Title of Invention: NON-CIRCULAR MICRO-VIA

**REQUEST FOR CERTIFICATE OF CORRECTION OF PATENT
FOR PTO AND/OR APPLICANT'S MISTAKES (37 CFR 1.322(a) and 1.323)**

DETAILED ACTION

FIG. 2

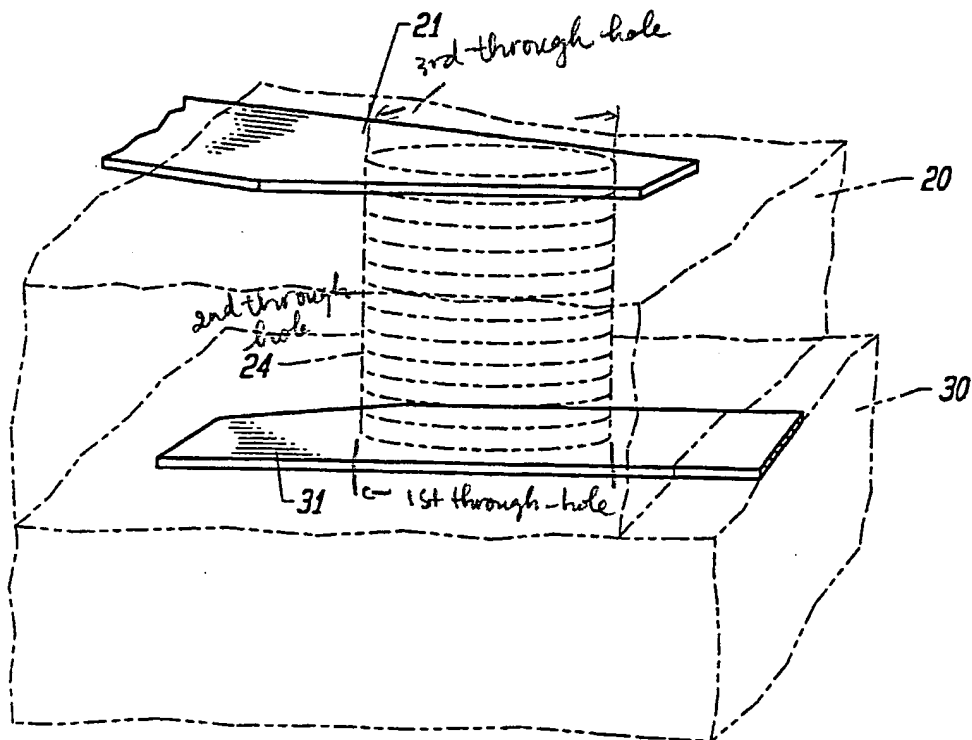
As to claim 1, Sen et al. disclose in Figs. 2-3F a wiring connection structure for printed circuit board, characterized by: a through-hole (24 in Fig. 2 or Figs. 3A-3F) with a convoluted shaped cross section having an interior wall that vertically extends through and intersects and exposes a plurality of wire circuit traces (21, 31) and a plating of conductive material is inherent applied to the interior wall electrically connecting a plurality of wire exposed circuit traces on a plurality of circuit layers.

As to claims 3-4, 13 and 16, Sen et al. disclose in Figs. 2-3F (also see attachment) a wiring connection structure having a first wire circuit trace (31) having a width applied to a main surface (30) and having a first terminal land pad with a terminal width the same as the width of the first wire trace and having a first through hole with a major and minor diameter where in minor diameter where the minor diameter is less than the width of the first trace and the major diameter is elongated and directional along a direction of the terminal landing pad; a printed circuit board first insulating layer (20) formed over the first wire trace having a second through hole (24) having identical geometry and orientation as and vertically aligned with the first through hole and extending to the first wire trace terminal landing pad; and second wire circuit trace (21) applied to the printed circuit board first insulation layer having a second terminal land pad with a third through hole having identical geometry to and aligned with the first through hole, wherein the first, second and third through holes are adjoining and are plated there through with an electrically conductive material forming a plated through hole vertically intersecting the first and second terminal pads and electrically connecting the first wire trace and the second wire trace by a connection between the first and second landing pads and the through hole.

As to claims 14-15, *Sen et al.* disclose in Fig. 3 wherein the major diameter is at least about twice / three times that of the minor diameter.

Sen et al. disclose in Figs. 3A-F a through hole has a shaped continuous curve cross section. It would have been obvious to one of ordinary skill in the art at the time of the invention was made to employ the through hole having a convoluted shaped cross section, as Sen et al. in order to have a characteristic inductance property.

FIG. 1

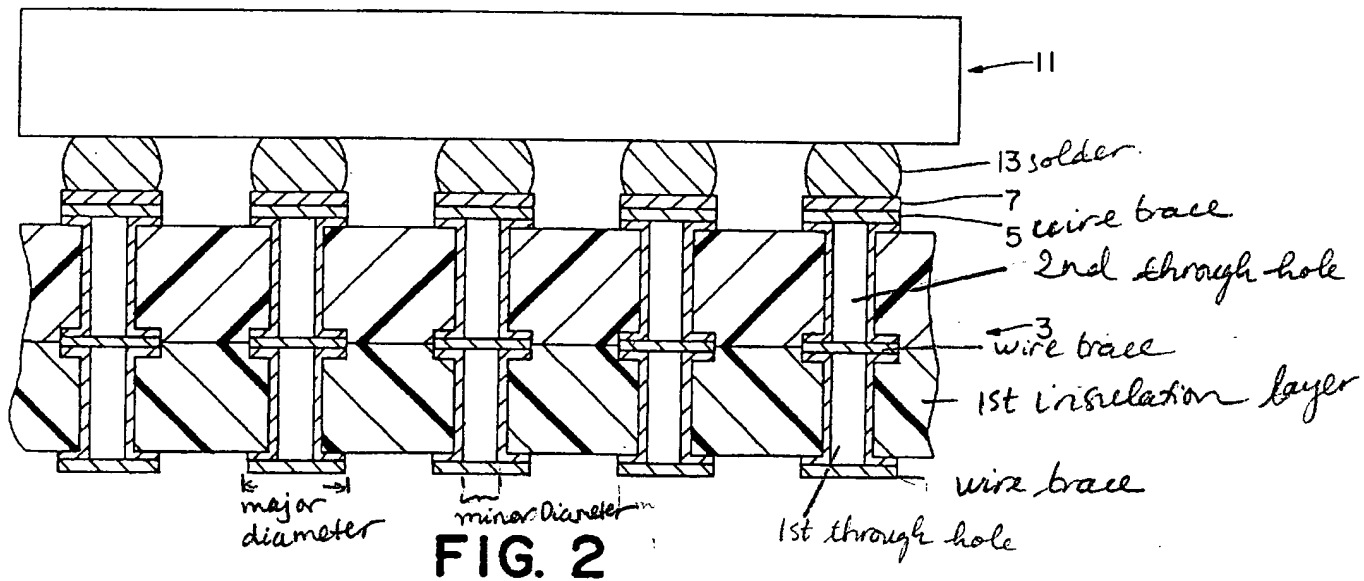
Kaperman et al. disclose in Figs. 1-2 (also see attachment) a wiring connection structure for a printed circuit board, characterized by: a first wire trace applied to a main surface having a first terminal land pad with a first through hole there through-hole; a printed circuit board first insulation layer formed over the first wire trace having a second through hole of identical cross sectional geometry and vertically aligned with the first through hole and extending to the first terminal landing pad exposing a portion of the first land pad; and a second wire trace applied to the printed circuit board first insulating layer having a second terminal landing pad; wherein the first and second through holes are adjoining and are plated there through with an electrically conductive material forming a plated through hole; wherein the vertically intersects the first and second terminal pads and electrically connects the first wire trace and the second wire trace by a connection between the first and second wire trace terminal landing parts and the plated through hole. Kaperman et al. disclose only two through holes are connected. However, it would have been obvious to one of ordinary skill in the art at the time of the invention was made to employ more than two through holes (i.e. another third through hole having identical geometry with the first and second through holes, as Kaperman et al. taught in col. 1, lines 48-50 or col. 2, lines 47-50) in order to improve surface for mounting electronic device. Kaperman et al. do not disclose the through hole having a convoluted shaped cross section.
